RENESAS TECHNICAL UPDATE

Product Category	MPU/MCU		Document No.	TN-SH7-A792A/E	Rev.	1.00
Title	SH7730 Hardware Manual revision up		Information Category	Technical Notification		
Applicable Product	SH7730 Group	Lot No. All	Reference Document	SH7730 Group Hardware Manual (REJ09B0359)

SH7730 Hardware Manual is revised from Rev.2.00. to Rev.3.00

11.1 Features	282	Description amended 6. PCMCIA interface • Supports IC memory cards and I/O card interfaces defined in the JEIDA specifications Ver. 4.2 (PCMCIA2.1).
Figure 11.1 Block Diagram of BSC	283	Figure amended

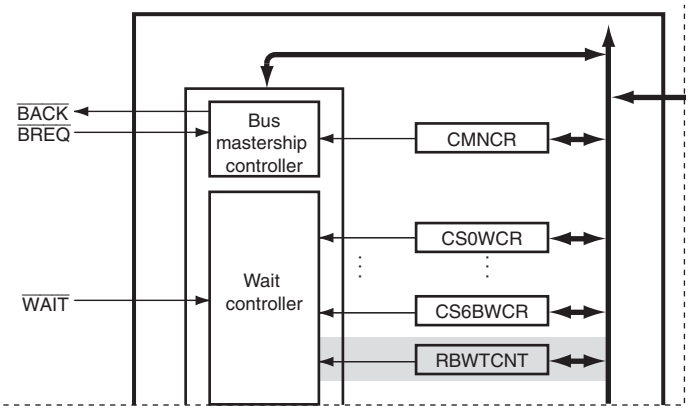
11.1 Features Figure 11.1 Block Diagram of BSC		Legend added [Legend] RBWTCNT: Reset bus wait counter
11.4 Register Descriptions Table 11.7 Register Configuration	292	Table amended

Figure 17.1 RTC Block Diagram

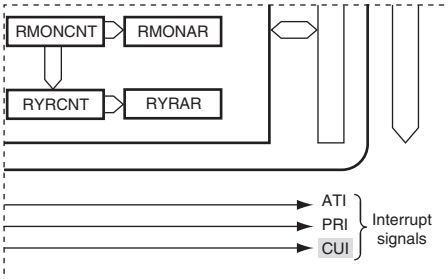
Figure amended

Figure 22.14 Example of SCIF Transmit Operation

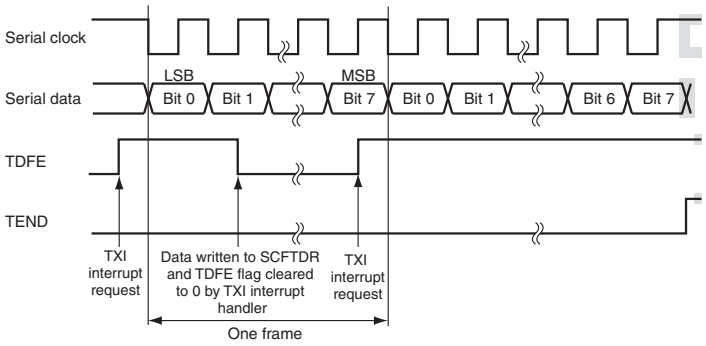
Figure amended
